Subject: FW: RB2 Review of Parcel E-2 Draft Final Phase II RACR

For your review and distribution, please find the updated Response to Comments (RTC) file to the Draft Final Remedial Action Completion Report, Parcel E-2 Phase II.

Response to Comments on the Draft *[Final]* Remedial Action Completion Report, Parcel E-2 Phase II, Hunters Point Naval Shipyard, San Francisco, California, June 2020, DCN: APTM-2005-0013-0047

*Comments by: Jeff White, San Francisco Bay Regional Water Quality Control Board, comments dated March 6, 2020; **follow-up on August 7, 2020***

DRAWING C6

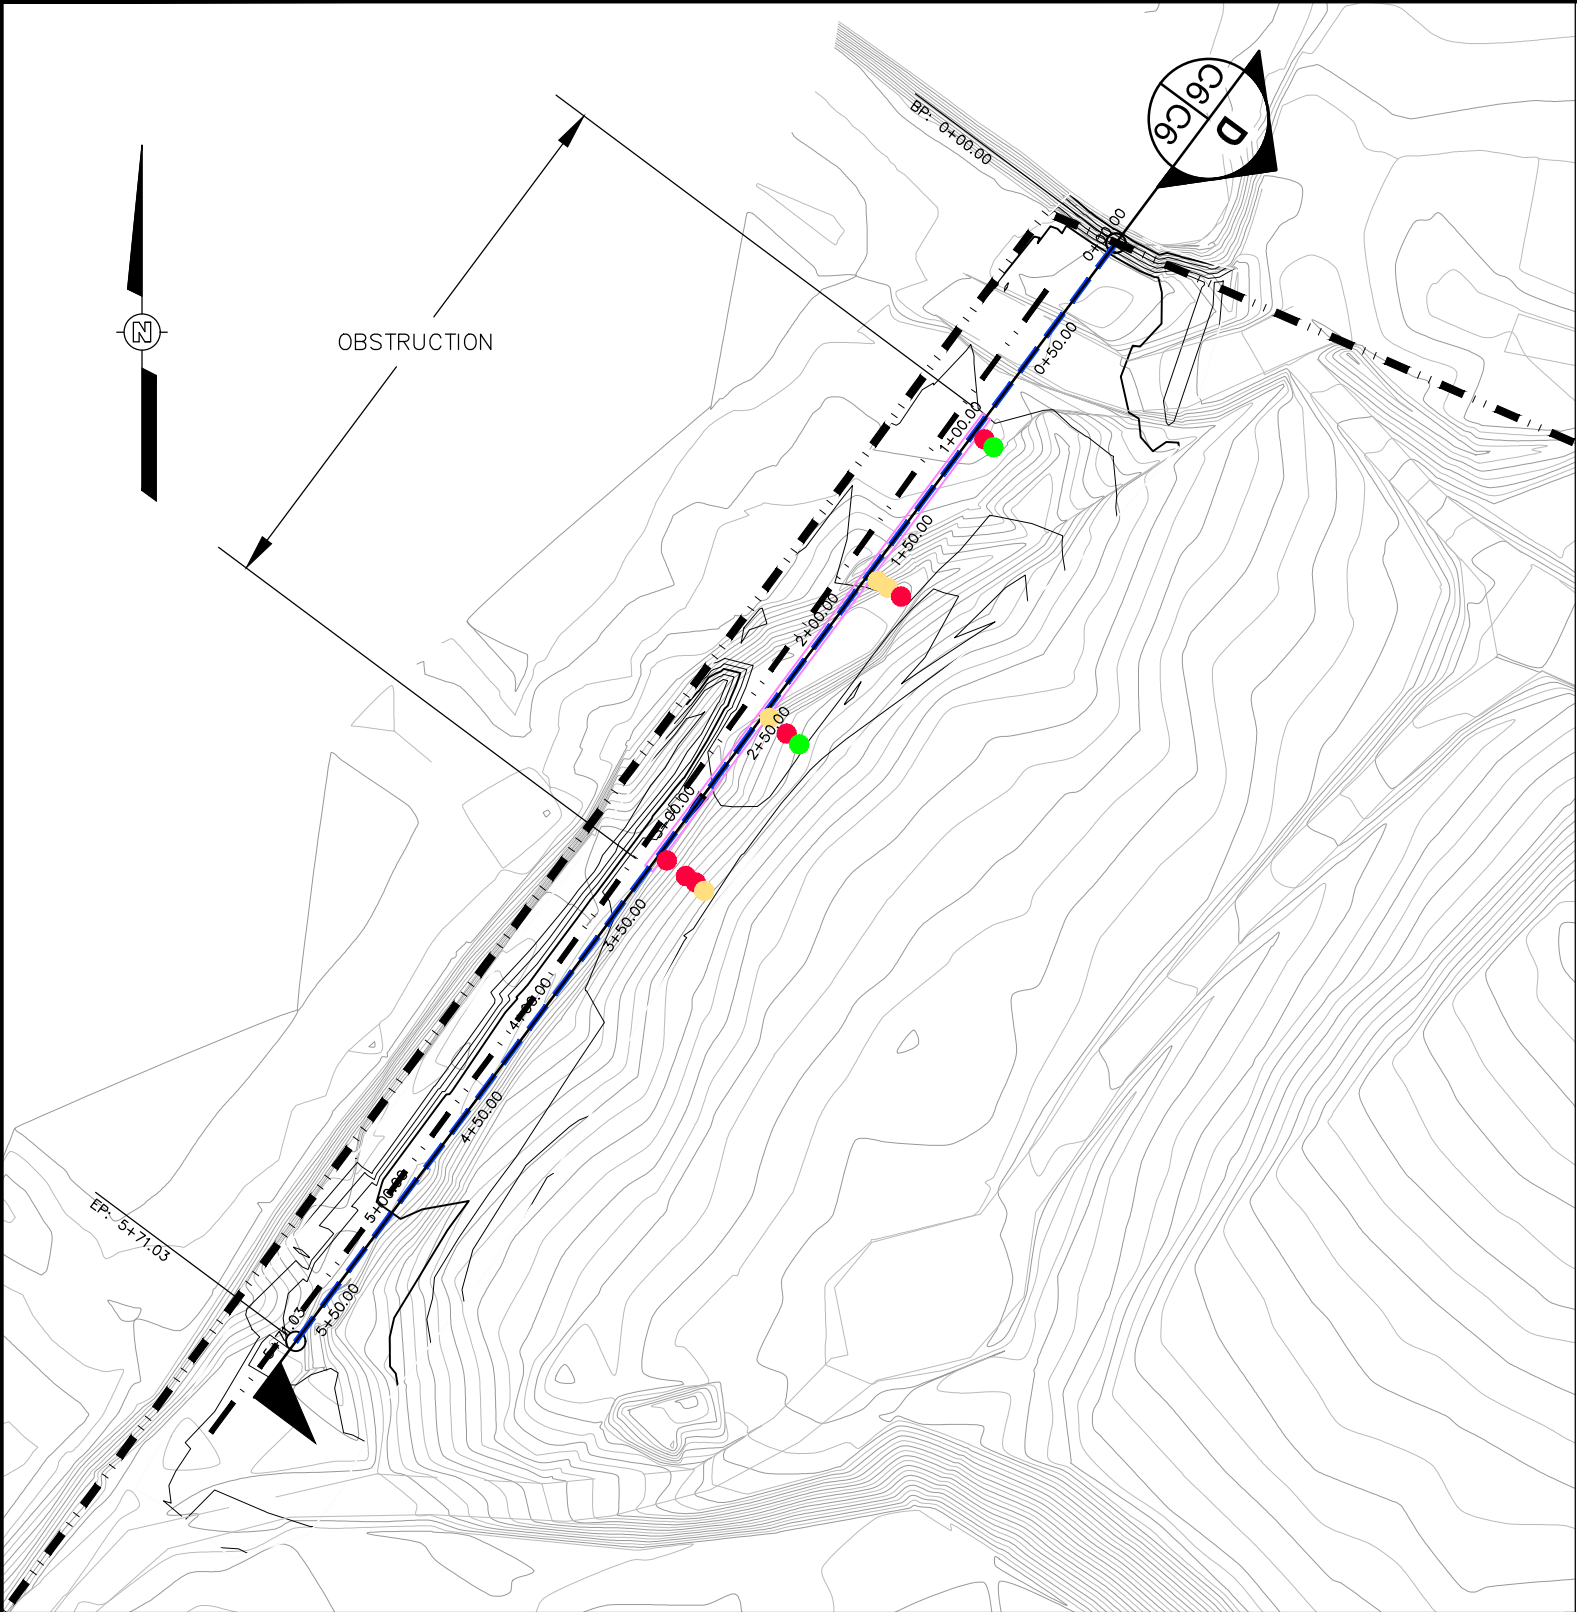
<p>6. Appendix C Construction As-Built Drawings. Drawing C6 Foundation Grading As-Built</p> <p>The contours shown on this drawing differ from those shown on Drawing C2 Shoreline Revetment Finish Grading As-Built. The text report states that Phase II remedial action completion left finished grades as foundation layer grades. The drawings should be reviewed and revised to remove the discrepancies.</p> <p>[DTSC] The drawing was not included in the most recent submittal. However, the contours on Drawing C2 appear to have been updated to match Drawing C6, as stated in the RTC. We have no further comment.</p>	<p>As-built Drawing C2 was only intended to show the as-built conditions at the shoreline, while as-built Drawing C6 represents the final as-built conditions of the foundation grade. However, to help avoid confusion, the contours shown on as-built Drawing C2 have been updated to the final foundation grade as suggested within the figure title.</p>

DRAWING C7
UPLAND SLURRY WALL AND FRENCH DRAIN AS-BUILT

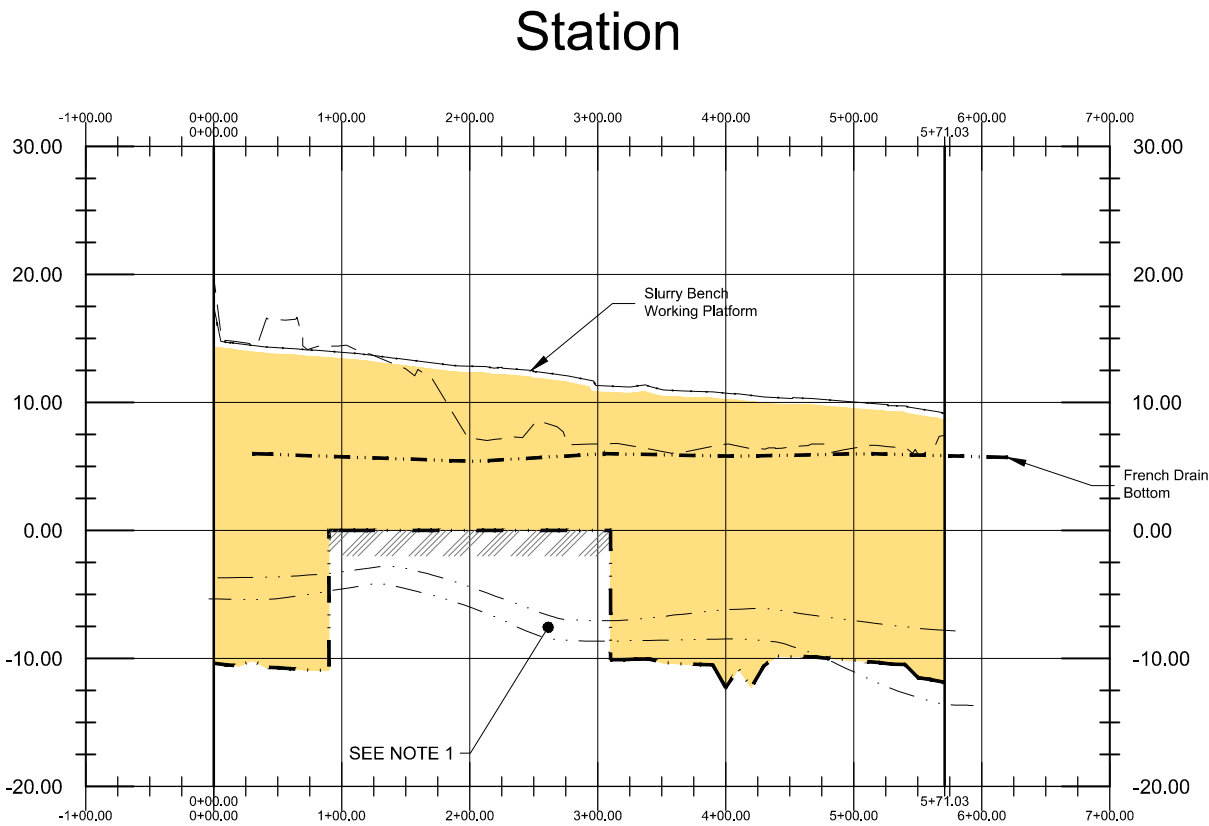
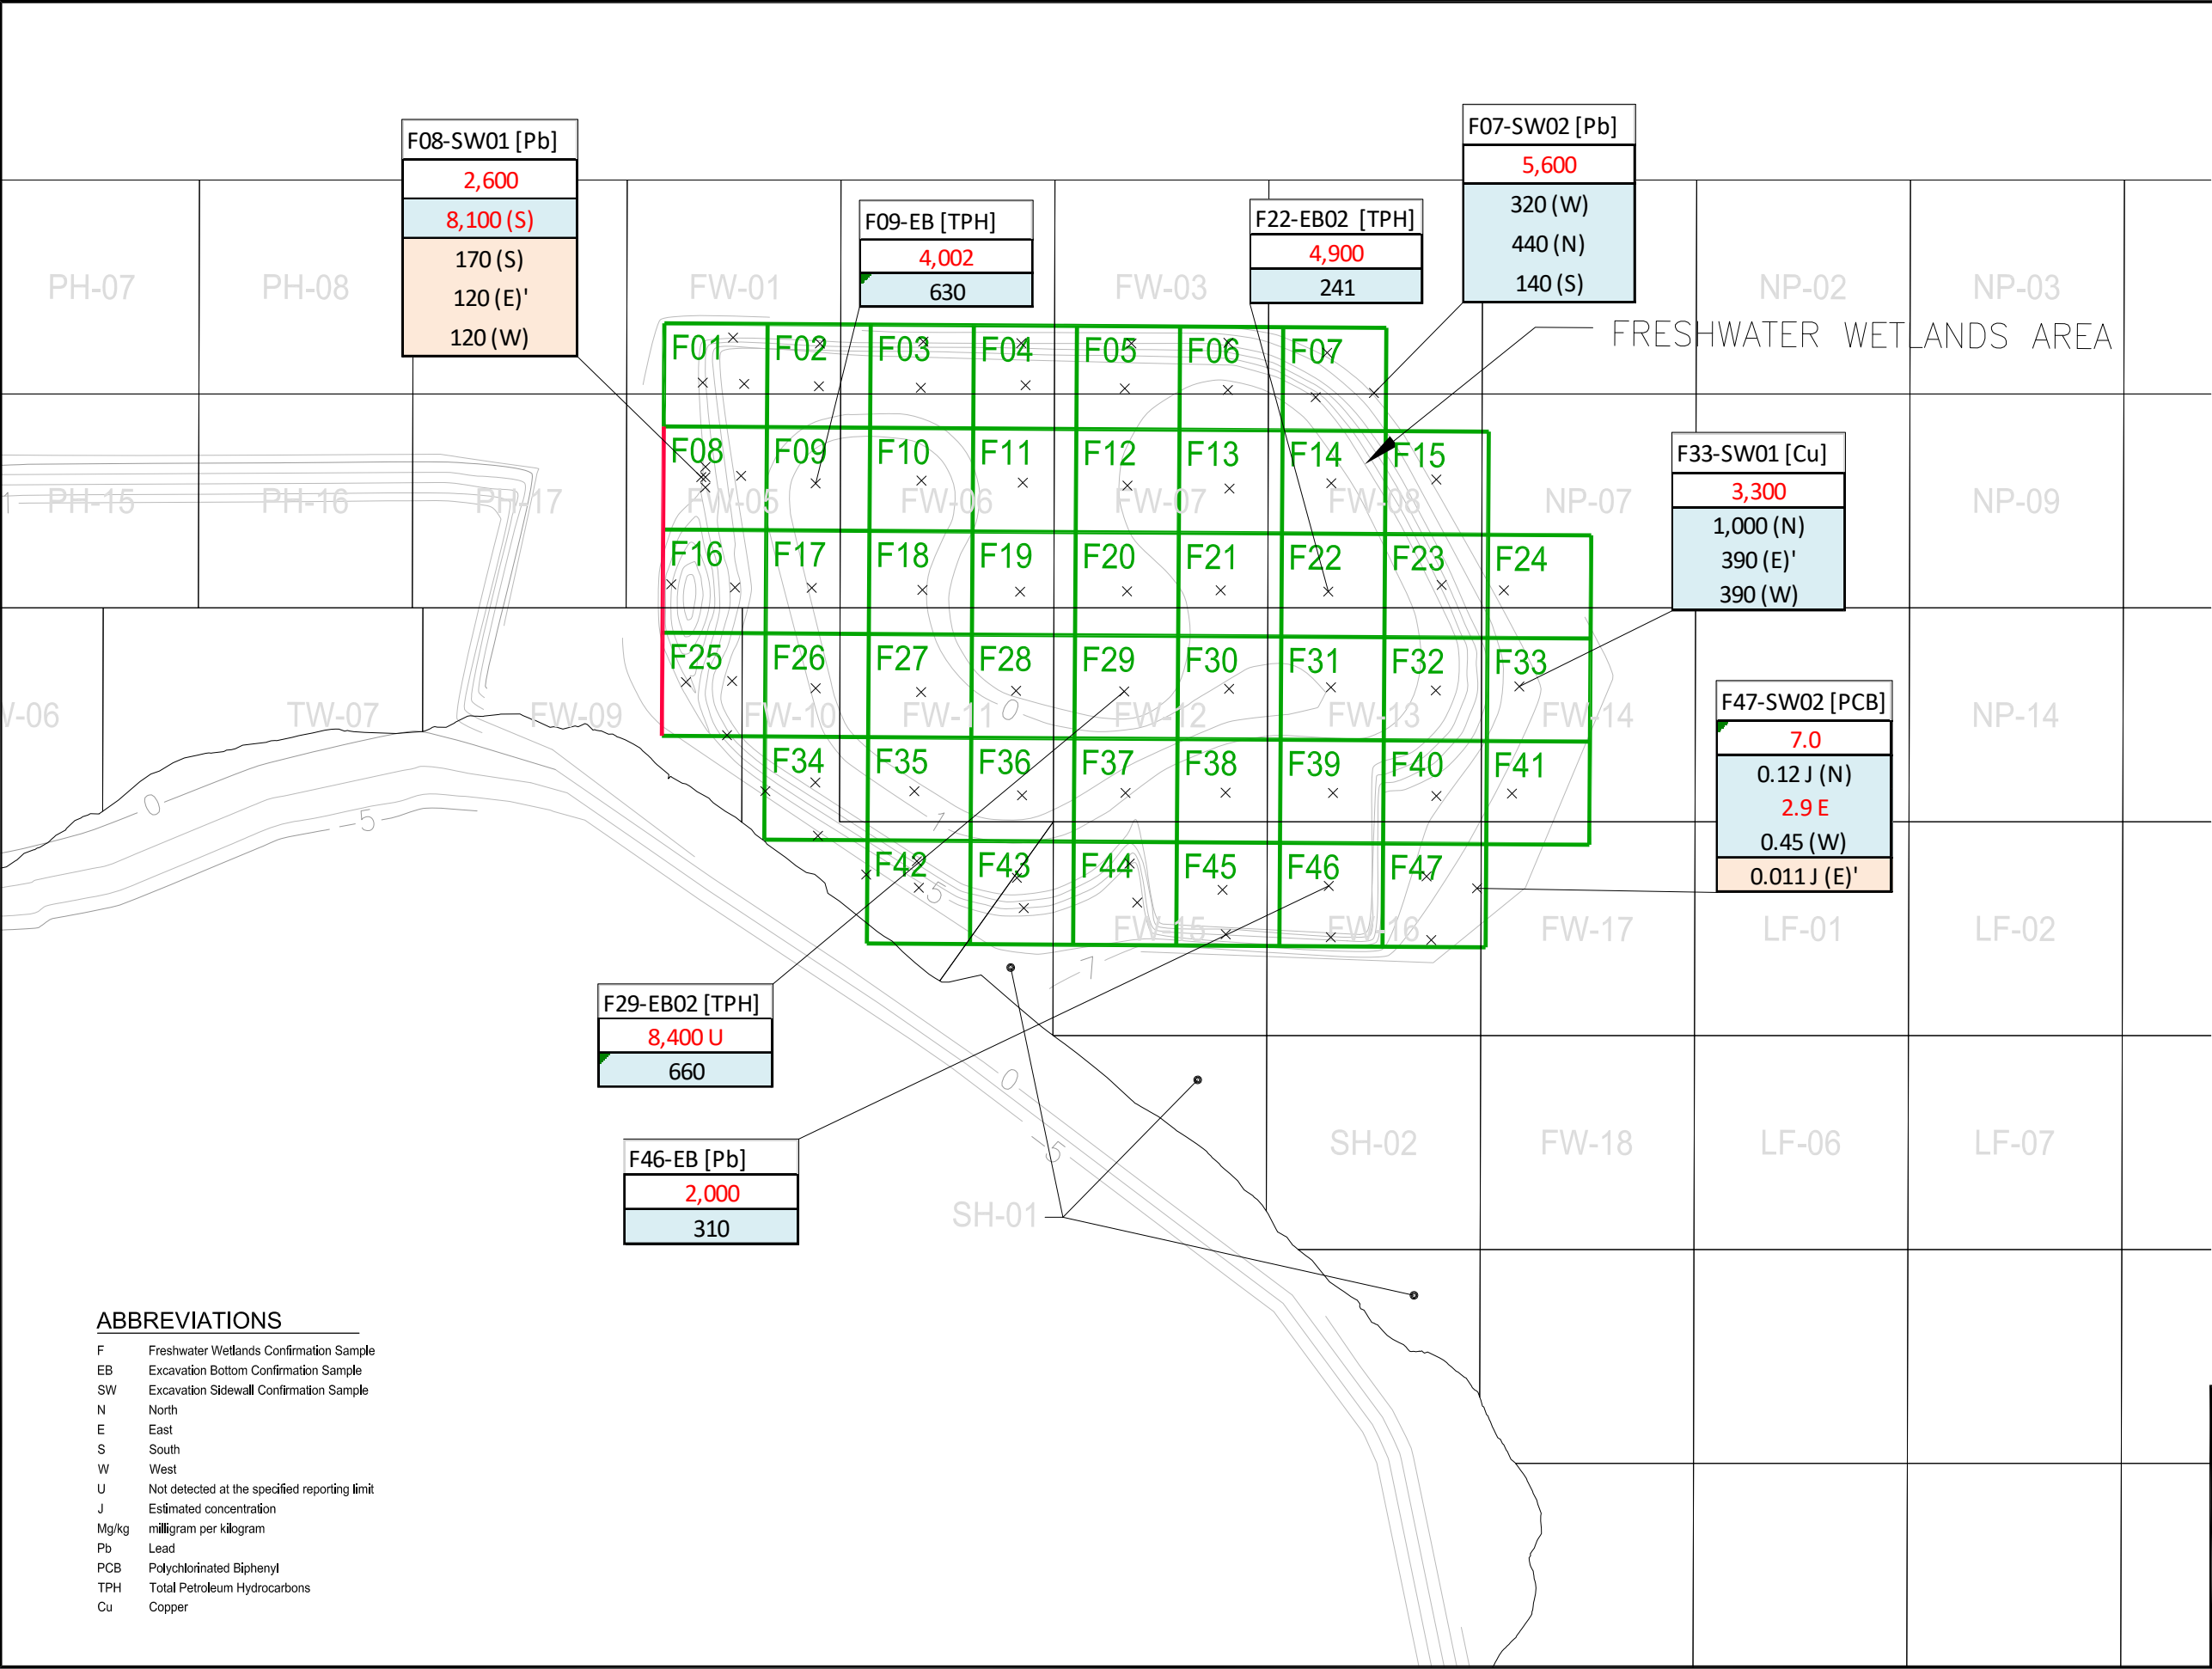
<p>7. Appendix C Construction As-Built Drawings. Drawing C7 Upland Slurry Wall and French Drain As-Built. The Profile View Alignment – (Upland Slurry Wall) shows a bottom slurry wall elevation of about – 10.00 feet with an approximate 200-foot section with a bottom elevation of elevation 0.00 feet. Note 1 associated with the profile states that the Bay mud for the section is noncontiguous and not considered an aquitard. However, we note that the third sentence in the second paragraph in Section 3.7.2.2 Wall Depths of the August 2014 Final Design Basis Report, Parcel E-2 states that</p>	<p>As-built Drawing C7 is a true and correct representation of the upland slurry wall which is described in the final paragraph in Section 3.7.2.2 of the DBR (ERRG, 2014). As described in the DBR, “The upland slurry wall will be installed from the designed finish grade, down through a thin noncontiguous lens of Bay Mud (identified in the boring logs as clay with shell fragments), to an elevation of approximately -10 feet below msl.” The details described in paragraph two of Section 3.7.2.2 of the DBR are</p>

[DTSC] Drawing C7 was not provided for review. The RTC states that as-built drawing C7 is a true and correct representation of the upland slurry wall. However, we note that the profile section shows the bay mud as extending across the obstruction encountered on an approximate 200-foot section of the slurry wall. This depiction appears to be incorrect as the direct-push drilling completed to evaluate the obstruction reported either complete refusal or difficult drilling which does not appear to support the presence of bay mud within the obstruction. We recommend the profile section is revised to show the correct as-built location of the bay mud layer and the notes are expanded to include an explanation of the obstruction encountered during installation, and hence the deviation from the approved design.

As cited within the legend of Drawing C7, the approximate depth to bay mud presented for this section was as defined in the final DBR (ERRG, 2014). Furthermore, the notes on Drawing C7 state that the bay mud layer for this section is noncontiguous and not considered an aquitard. Since the upland slurry wall was designed as a hanging wall, i.e., it was not intended to key into an aquitard, subsurface investigation for the purpose of mapping the location of the bay mud layer in this area is considered outside the scope of the Phase II contract.

No additional changes to Drawing C7 are recommended; however, if requested, all references to the subsurface stratum as defined within the DBR may be removed.

FIGURE 6
FRESHWATER WETLAND FINAL CHEMICAL
CONFIRMATION SAMPLE GRIDS
REMEDIAL ACTION COMPLETION REPORT
PARCEL E2
HUNTERS POINT NAVAL SHIPYARD, SAN FRANCISCO, CA

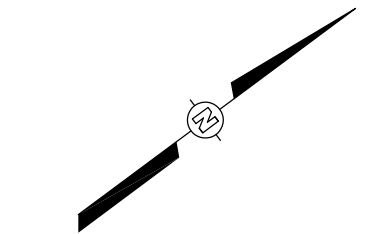
<p>9. Figure 6 Freshwater Wetland Final Chemical Confirmation Sample Grids</p> <ul style="list-style-type: none"> a) An explanation of what the red font in the sample results should be added to the legend. b) In the sample result boxes, some of the results are labeled with “N,” “E,” “S,” and “W.” While these appear to represent which sidewalls were sampled, these labels should be defined in the legend. c) A hot spot goal is provided only for lead on this figure, when other constituent results are presented on this figure. The hot spot goals for copper, total petroleum hydrocarbons (TPH), and polychlorinated biphenyls (PCBs) should be included as notes on this figure. 	<p>For clarity, the following notes have been added to Figure 6.</p> <ul style="list-style-type: none"> a) Results shown in red indicate samples exceeding the project action limit. b) A list of abbreviations has also been added to Figure 6 to include: <ul style="list-style-type: none"> F – Freshwater Wetlands Confirmation Sample EB – Excavation Bottom Confirmation Sample SW – Excavation Sidewall Confirmation Sample N – North E – East S – South W – West Mg/kg – milligram per kilogram Pb – Lead PCB – Polychlorinated Biphenyl TPH – Total Petroleum Hydrocarbons Cu – Copper c) Hot spot goals for Cu, TPH, and PCBs have been added as recommended.
